48 HOUR INFORMATION FROM NEIGHBORS

Agenda Number: 5 Project #: 2018-001402,

Case #: SI-2018-00171, Hearing Date: February 13, 2020

Environmental Planning Commission

AMAFCA easement 12.20.19.jpg; AMAFCA easement 1.25.20.jpg

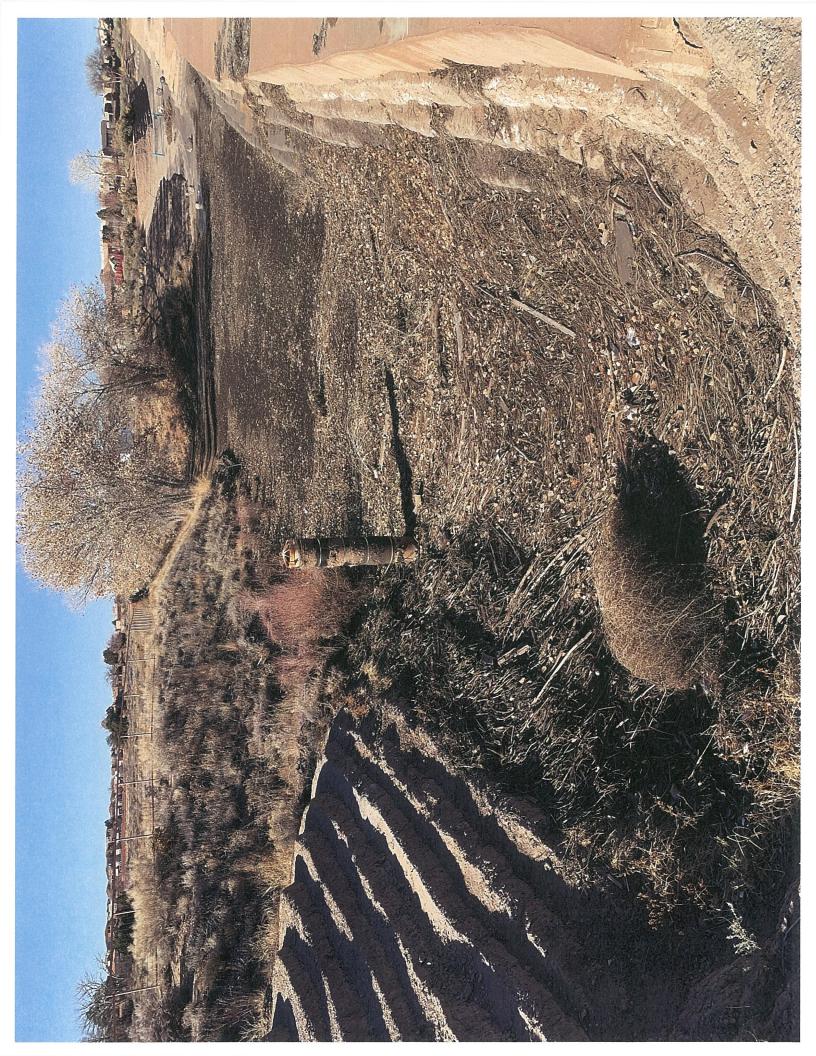
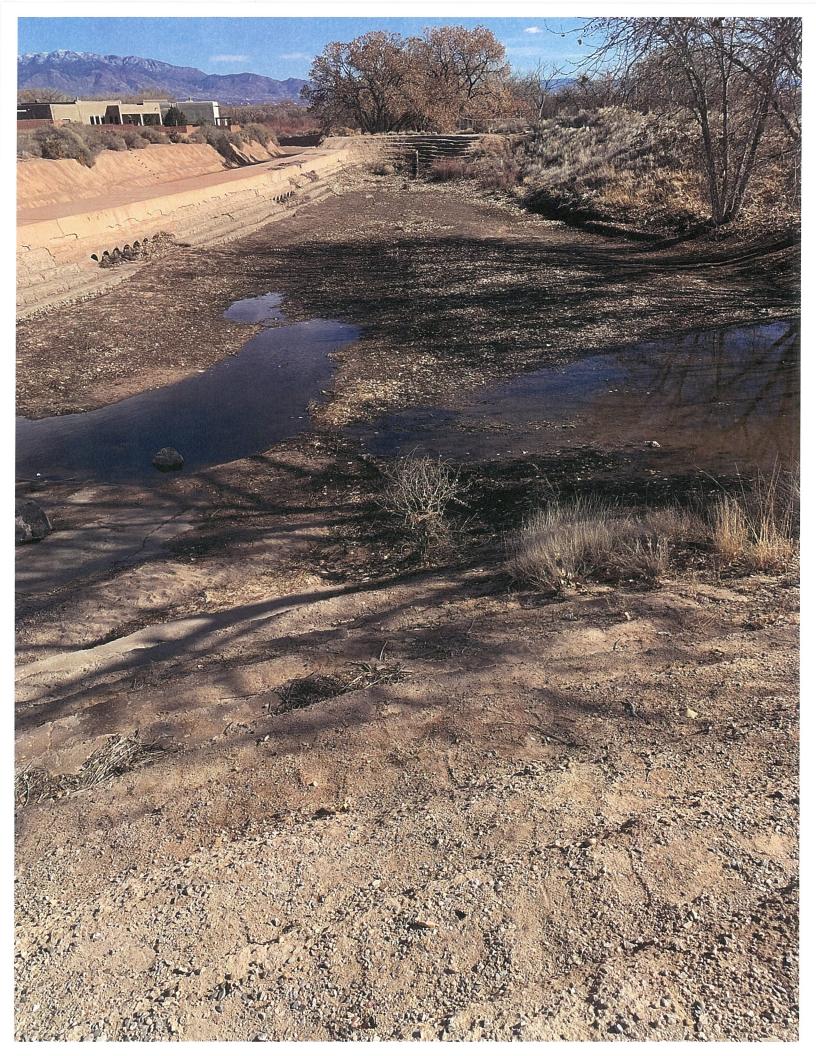
While I agree with much of your Supplemental Report, I believe your position stated on page 14 that the AMAFCA easement can be counted as Common Open Space because it is on-site ponding is incorrect.

The easement, when it has water in it after a substantial rainfall, is usually quite nasty, filled with weeds and debris carried down the arroyo from the west. But, more often than not, the easement is either dry or has a puddle or two in it. Just because there is occasionally nasty water or a puddle or two in it, the easement should not be considered on-site ponding. That is surely not what the term on-site ponding contemplates.

You cite the definition of Common Open Space which provides that the space must be for the use and enjoyment of the residents. You do not discuss how or why the residents will use and enjoy the AMAFCA easement. In fact, because of its condition, the residents will not use and enjoy the easement. The Open Space Division memo of December 16, 2019, page 2, supports that conclusion by stating that the "AMAFCA sedimentation pond" is "not well suited for public use and enjoyment."

I attached photos to my letter to Mr. Brito that show the typical nasty condition of the easement after a substantial rainfall and when the easement is dry. I now attach photos I took December 20, 2019, and January 25, 2020, to illustrate further how the so-called on site ponding often looks.

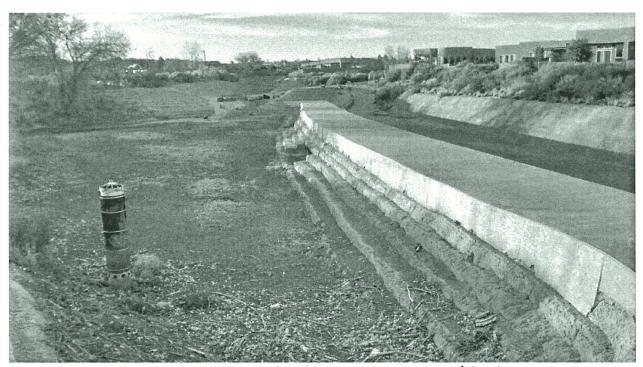
b) Cul de Sacs are prohibited. (Part 14-16-5: Development Standards 5-3(E): Subdivision Access and Circulation 5-3: Access and Connectivity 5-3(E)(1): Street Connectivity: 5-3(E)(1)(d) Stub Streets and Cul-de-Sacs: "Stub streets and cul-de-sacs that terminate the road are prohibited, with the following exceptions: Permanent stub streets are allowed only where a connection to an existing street and a future road extension is not possible or feasible." "Where allowed, stub streets are limited to 150 feet in length."

Please note, last year the applicant received a variance to close off 3 of the 4 exits on the north side of the property leaving only one emergency exit. Keeping the existing exits would have maintained the connectivity that the IDO promotes, especially for emergency situations. How can the applicant justify the cul-de-sacs when the variance they requested eliminated the three existing exits that already connected to adjacent streets?
